RE: 1272 Viscaino Road -FMP Amendment -PLN220251

1272 Viscaino Road -FMP Amendment -PLN220251

Tree Assessment
Forest Management Plan
Mansur Residence

I am reaching out for some clarification regarding a Tree Assessment that you completed for Dan and Tricia Mansur at 1272 Viscaino Rd in Pebble Beach. Attached are the Tree Assessment, the amendment to the Tree Assessment and a site plan with the trees in question circled in red.

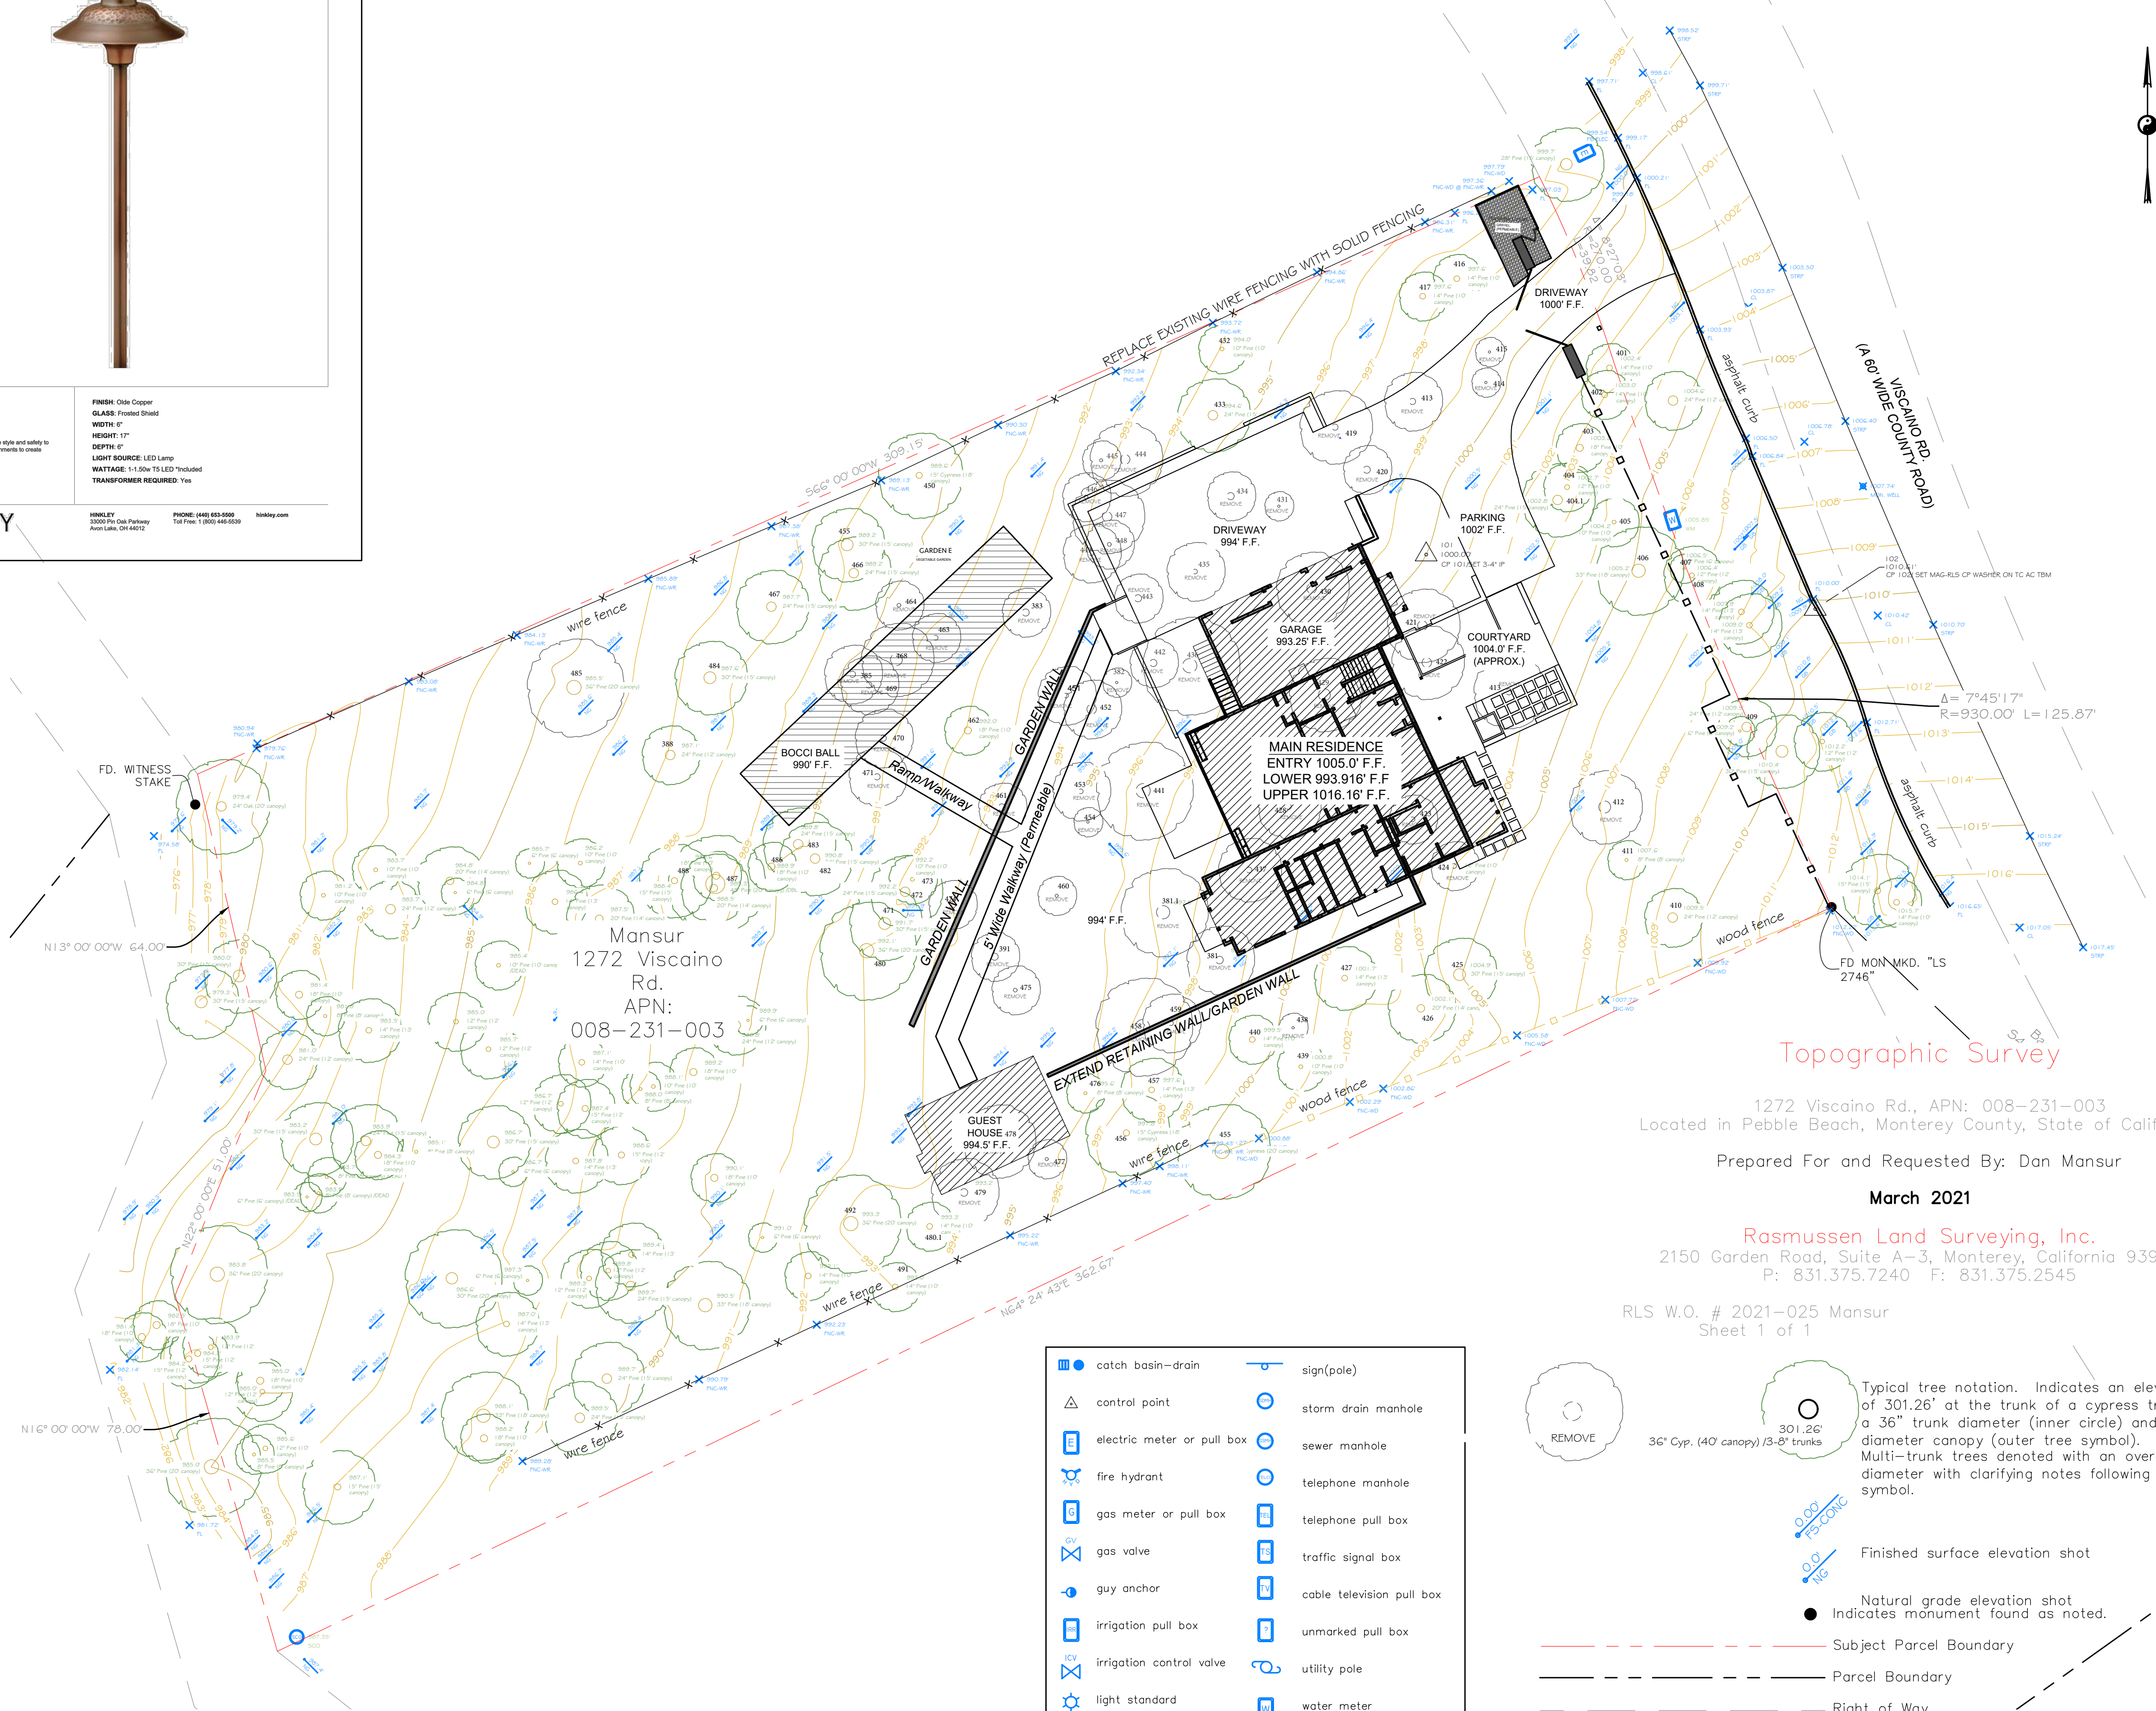
As the County Planner for this project, I must make the finding that the number of trees proposed for removal is the minimum under the circumstances. Approximately 30 to 35 trees are within the footprint of the house, patios and driveway or are directly adjacent to the proposed structure; these are justifiable under the circumstances.

There are about 15 trees that I'll need an explanation of why they are recommended for removal.

Tree 467, 466 and 465 are included on the removal list in the attached amendment dated 11/18/22. These trees are said to be in fair condition but are proposed for removal due to neighbor complaints. Can you please provide clarification if these trees will be impacted by the proposed development or are hazardous?

The other trees I have questions about include 425, 426, 433, 438, 441, 445, 454, 458, 459, 460, 461 and 470. From looking at the site plan, these 15 trees appear to be far enough away from the structure that they wouldn't be directly impacted. Please let me know if this is incorrect, my understanding is if the dripline of the tree is outside of the footprint of the development it can survive.

To help make the finding that these 15 trees must be removed for this development project to take place, I would appreciate it if you could please provide a little more detail regarding the individual trees and the recommendation for their removal.

I didn't have a grading sheet to study, but essentially grade changes are either accomplished by the placement of retaining walls or cutting the slope to re-establish the grade and improve water flow away from the structure. I am to understand that in this case, he is planning to install retaining walls; this will require soil overcut and removal of roots on trees that will not be accustomed to the newly exposed wind. As to stem bleeding, this is excessive resinosity, a product of pine pitch canker, a non-curable disease that has affected and slowly killed many of the pines in this forest.
